Product Change Notification

Date Issued :	March 27, 2026	PCN Number :	518063
Reason for Change :	Packaging Method/Quantity Changing		
Description of Change :	This notification is to inform you about part(s) listed will undergo changes for packaging size and material of packaging change. No changes will be made to product as part of this change.		
Assessment of Change :	Drop Test		
Planned Implementation Date :	September 30, 2026		
Customer Sample Availability Date:	May 15, 2026		
Last date to request Samples by Customer :	April 30, 2026		
Please note if Samples are not requested as per Customer Samples Request date, it may take additional 4-6 weeks to arrange Samples.

Packaging Specification

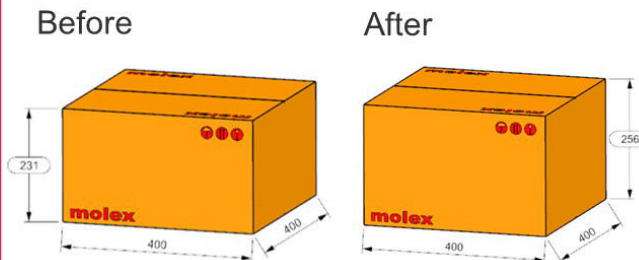
Internal Package Material Change

Box Size Change

- Further mitigate risk of final CPA locking caused by external force on parts during shipment (CPA final-lock can contribute to locking latch deformation to cause matting stop issue)
 - 1.Change package material from PE bag to Airbag.
 - 2.The box size change from 400*400*231 change to 400*400*256
- Part Number Impact
 - Please see attached part number.
- There is NO impact to fit, form or function; No impact to SPQ or MOQ.
- Drop test report available now, which can be provided basing on request.
- Delivery Unit no change, no samples will be provided.
- Level 1 PPAP with updated packaging print will be provided upon request.
